BAR Meeting  
October 21, 2009

**ISSUE:** Alterations  
**APPLICANT:** Jerry and Sara Kilkenny  
**LOCATION:** 500 North Columbus Street  
**ZONE:** CL/ Commercial Low Zone

Figure 9: Proposal - Rear Elevation (Door Removal/Brick Enclosure)

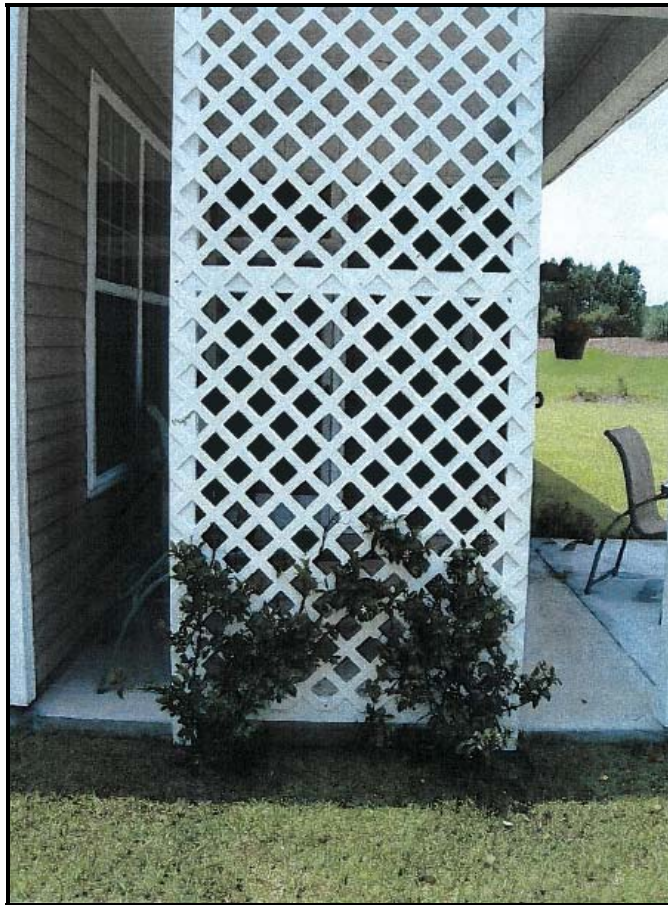
1. That the brick being utilized to fill in the rear door's opening be recessed a minimum of one inch from the existing wall surface.
2. That the proposed lattice trellis is fabricated from horizontal and vertical wood boards surrounded by a wood frame, rather than diagonal lattice as proposed.
3. That the proposed lattice trellis will be installed to disguise the door opening as well as the existing electrical meters located on the rear elevation.
4. The proposed lattice trellis will be free-standing.
